2019 Project Review Sheet (2020 Construction)

Project #	19-75
Project Title:	Improve Pedestrian Signal Timing
	Neighborhood: Othello, 98118
Location:	Area: MLK Blvd and Othello St intersection, especially the north side which provides access to the light rail station.
	SDOT Contact Information
SDOT Reviewer Name:	Laura Wojcicki & Matthew Dunlap
Reviewer Phone Number:	206-684-8855
Review Date:	August 7 th , 2019
	SDOT Project Summary
SDOT approves project	
☐ Yes ⊠ Yes, with revision	5
□ No	5
determine if a change in the discussions with Sound Tran does recommend installing	nis review, SDOT is still awaiting pedestrian actuation data to e signal timing is warranted. Additionally, SDOT is having ongoing nsit with improving overall operations for all users. However, SDOT additional pedestrian signal countdown heads in the median to pedestrians going to and from the platform.
There is an opportunity to p	partner with another program:
⊠ No	
Partnering Program: N/A

Image:

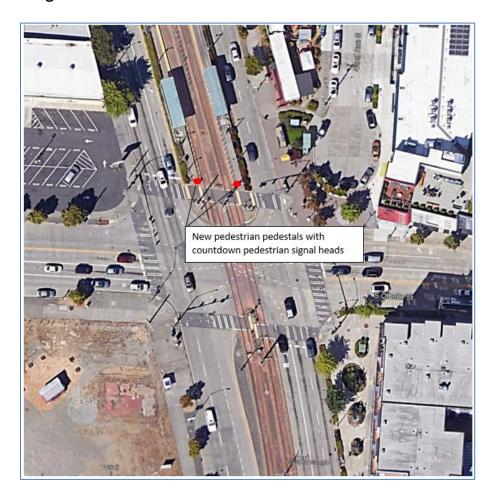
Our team has completed a review to determine if the proposed updates to this signal are feasible. For the first proposed item, our team has requested pedestrian actuation data to determine how frequently pedestrian phases are run during an average day. Unfortunately, we are still waiting for this data to get collected. Once we have this data, we will be able to determine if we would potentially be able to remove the pedestrian pushbuttons and service the pedestrians crossing MLK Wy at Alaska every signal cycle. An alternative to removing the buttons would be to initiate a pedestrian recall during the busy times of day when many pedestrians are crossing. A recall would remove the need for pedestrians to press the button in order to be served.

For the second requested item, our team recommends installing additional pedestrian countdown signal heads on the median station platform area on the northside of this intersection: one pedestrian head facing westbound to signal to pedestrians when it is time to cross from the westside, and on pedestrian head facing eastbound to signal when it is OK to cross from the eastside.

Regarding the third requested item of "reducing the interval between pedestrian phases", we are engaged in an ongoing conversation with Sound Transit with the goal of improving overall operations for all road users along the MLK Wy light rail corridor. The problem of large wait times for pedestrians comes as a result of our signal being programmed to provide priority service to the Link Light Rail train. The signals will skip another movement in order to serve the NB and SB directions of the Light Rail Train. Signal timing changes made in August 2018 potentially reduced the amount of skipping that occurs to service the train, however, because we prioritize the train, skipping other movements is necessary to ensure that the train can maintain reliable operations.
